<b>Project</b>	Steamboat Base Village Redevelopment	<b>Date</b>	08/04/2021
<b>Project Location</b>	Steamboat, Colorado	<b>Architect's Project Number</b>	03.7835.000
<b>Owner/Client</b>	Alterra Mountain Company / East West Partners	<b>File</b>	6BL <b>This is page</b> 1 of
<b>To</b>	Saunders Construction Inc.	<b>Attention</b>	Bryan Sculthorpe
<b>Address</b>	86 Inverness Place North		
<b>City</b>	Englewood	<b>State</b>	CO <b>Zip Code</b> 80112
<b>Delivered via:</b>	<input type="checkbox"/> <b>Messenger</b> <input type="checkbox"/> <b>Hand carried</b> <input type="checkbox"/> <b>Facsimile</b> <input type="checkbox"/> <b>Express</b> <input type="checkbox"/> <b>Pick-up</b> <input type="checkbox"/> <b>E-mail Address</b> <input type="checkbox"/> <b>Mail</b> <input type="checkbox"/> <b>UPS</b> <input checked="" type="checkbox"/> <b>Website Address</b> BIM360

<b>Attachments</b>	BP3 Goldwalk - BULLETIN 05		
<b>Requested by</b>	<input checked="" type="checkbox"/> Architect <input type="checkbox"/> Owner <input type="checkbox"/> Contractor <input type="checkbox"/> Other (specify): _____		
<b>Issued by Gensler by</b>	Juan Padilla	<b>Date Signed</b>	08/04/21
<b>Issued by Owner by</b>		<b>Date Si

## 1B-E0.001

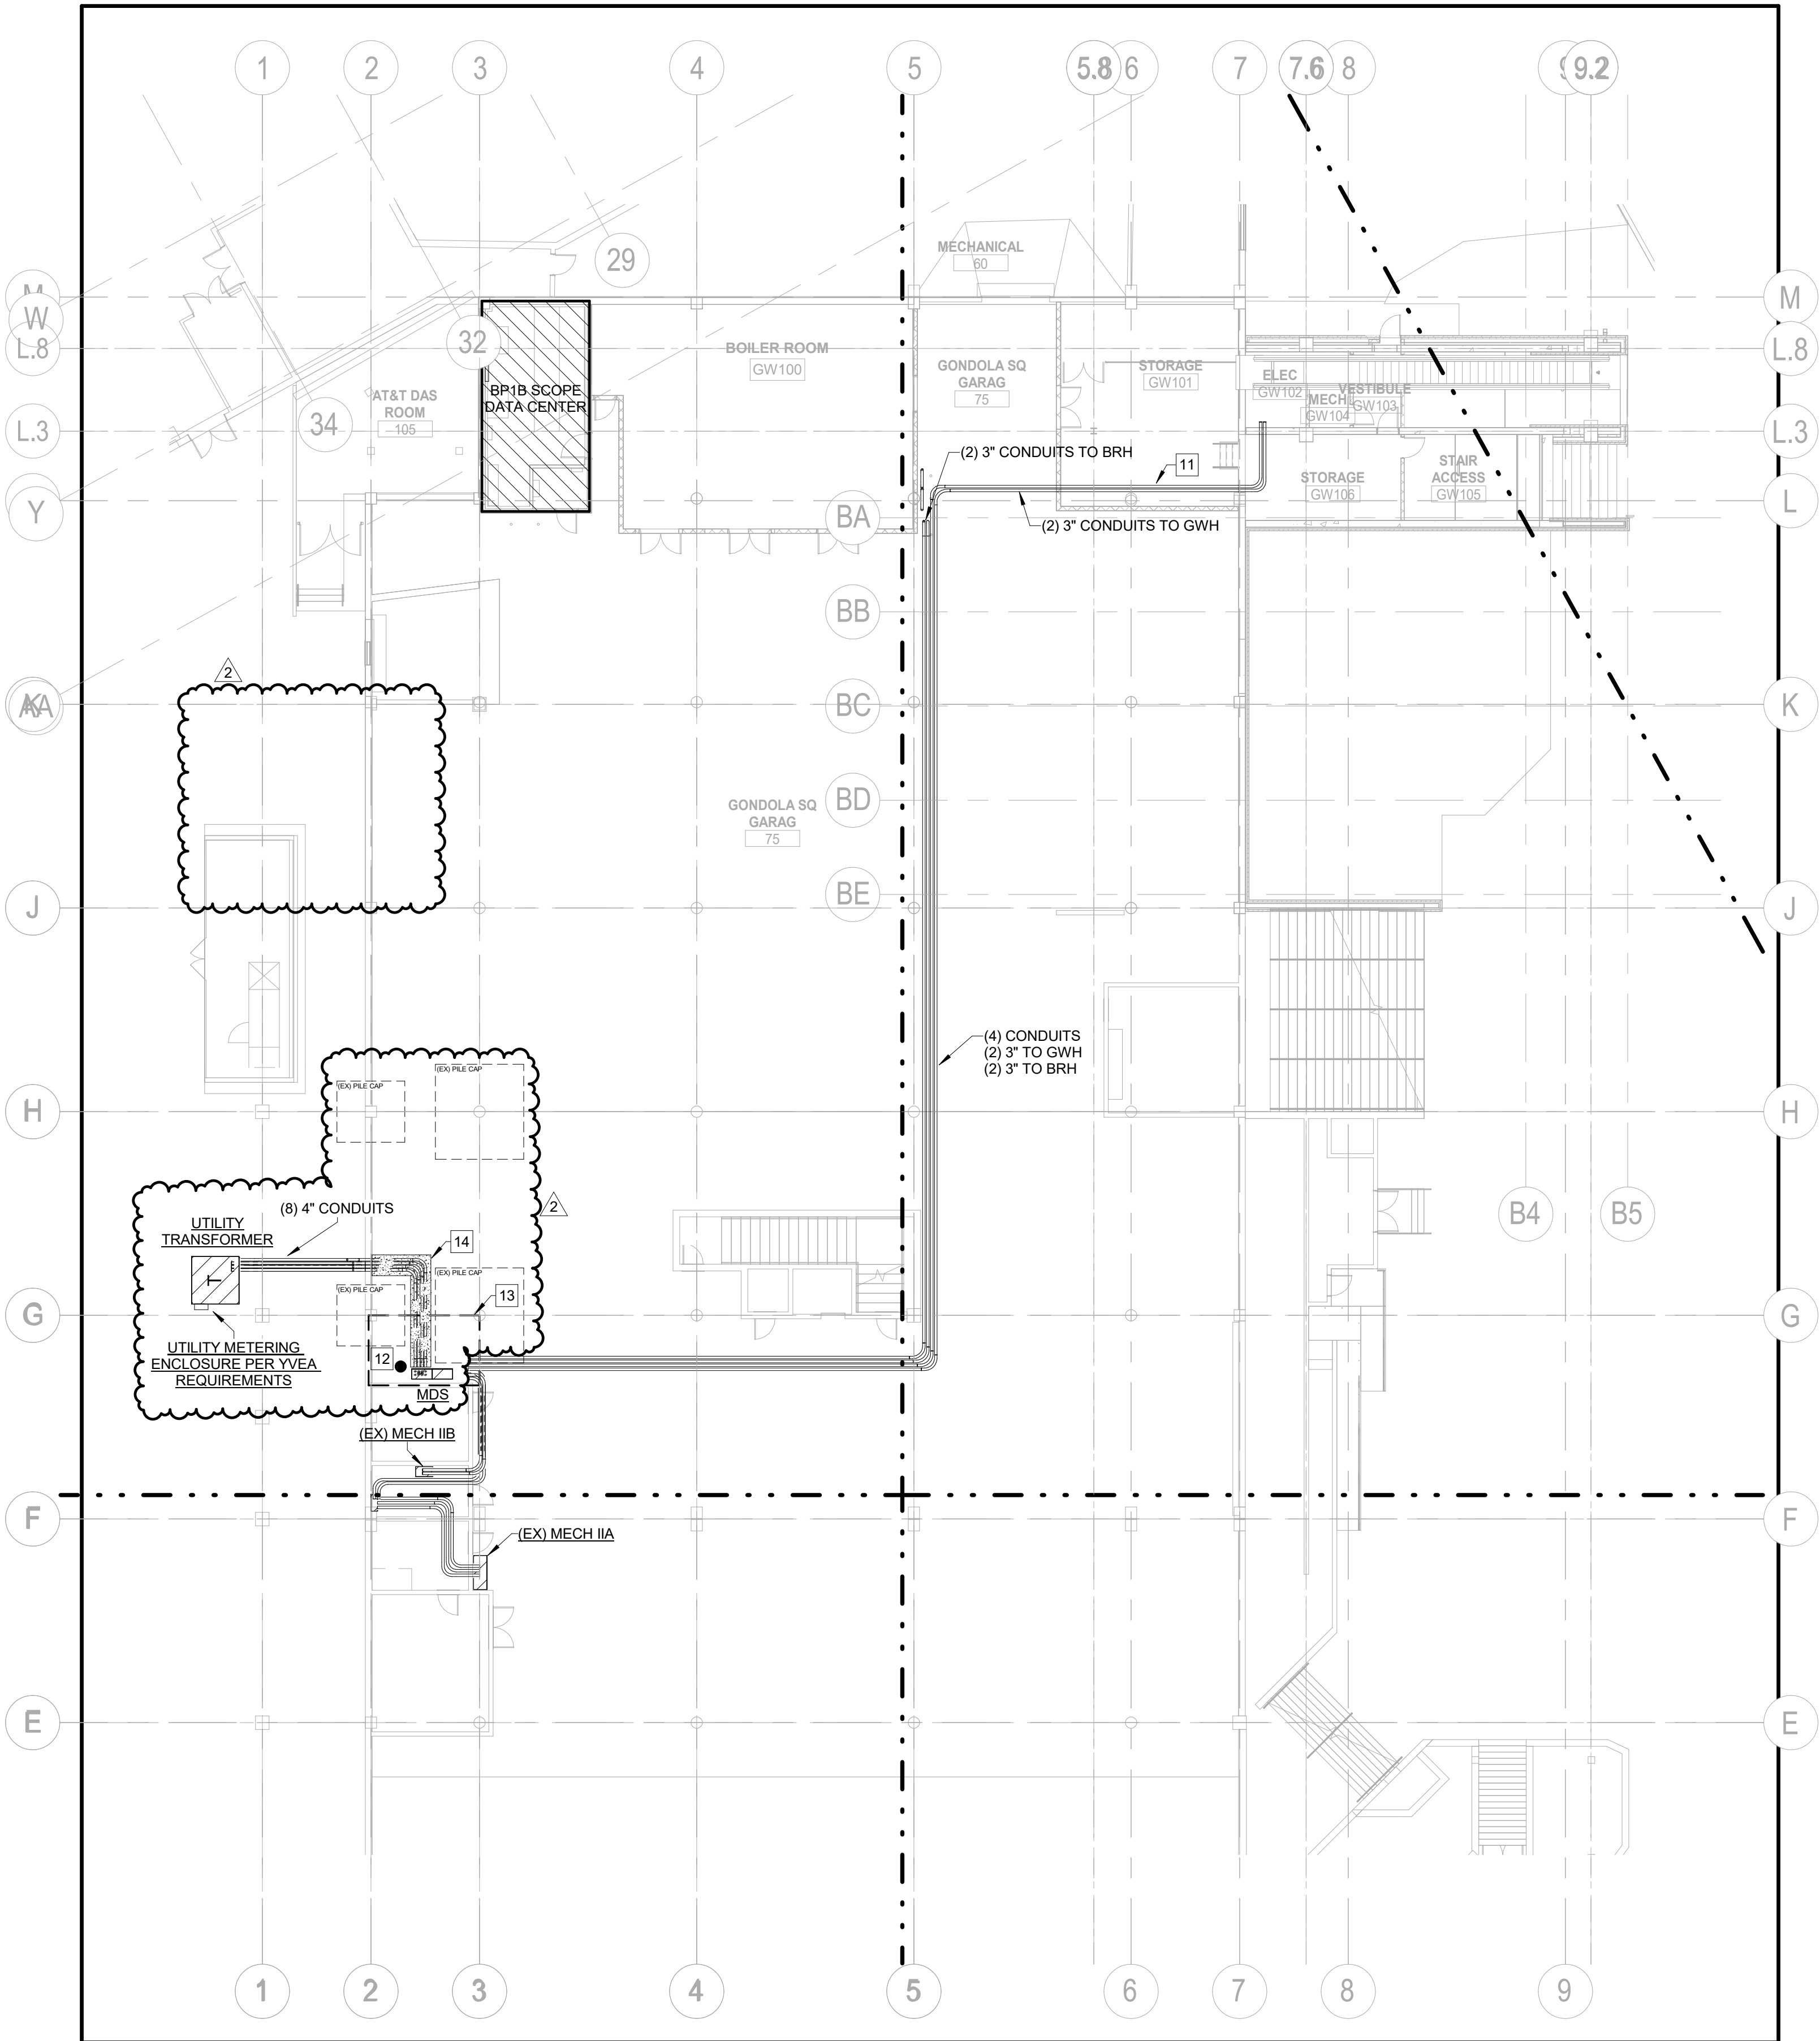
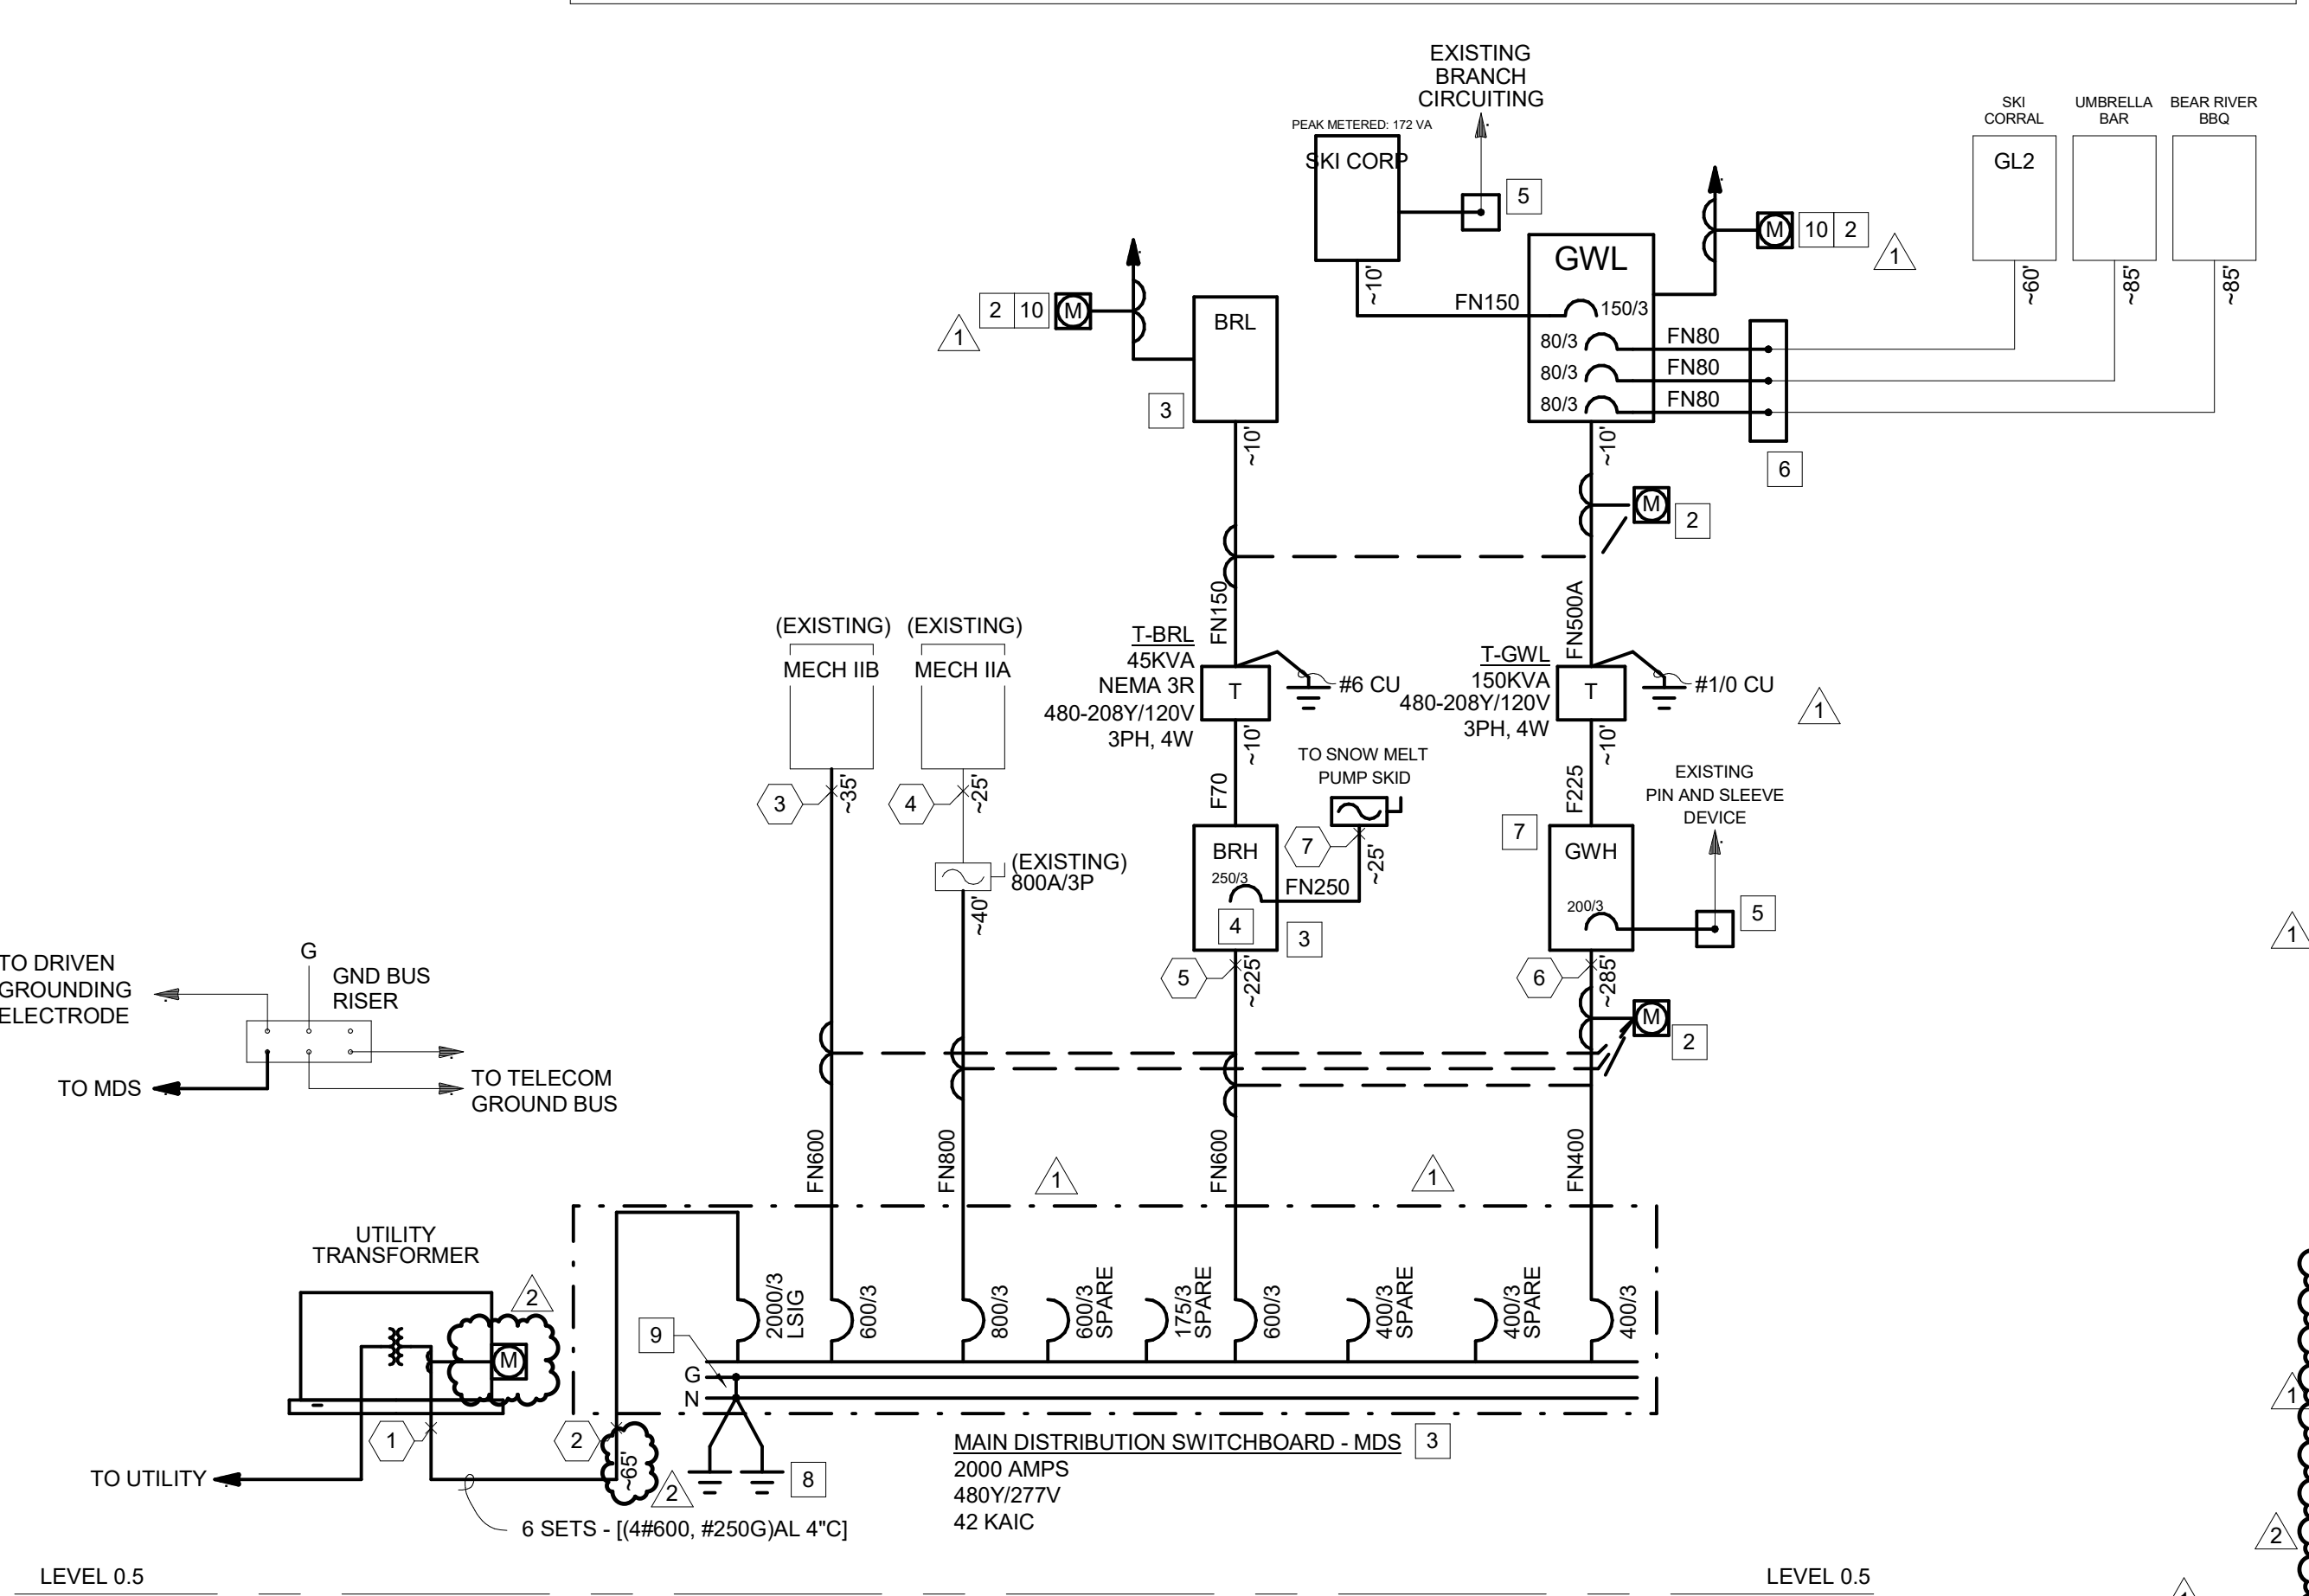
1. 1B-E0.001
  - a. Modified location of new Utility transformer associated with gold walk and Gondola Square loads.
  - b. Modified electrical short circuit values associated with secondary feeder distance reduction.
  - c. Added existing pile caps for reference as reviewed on existing building drawings.
  - d. Added clarification notes to general notes and keynotes for installation of secondary duct bank to be routed under foundation and into electrical gear per coordination with General Contractor.
2. 1B-E8.000
  - a. Added electrical detail for underground concrete encased duct bank from secondary of transformer to electrical service entrance switchboard.
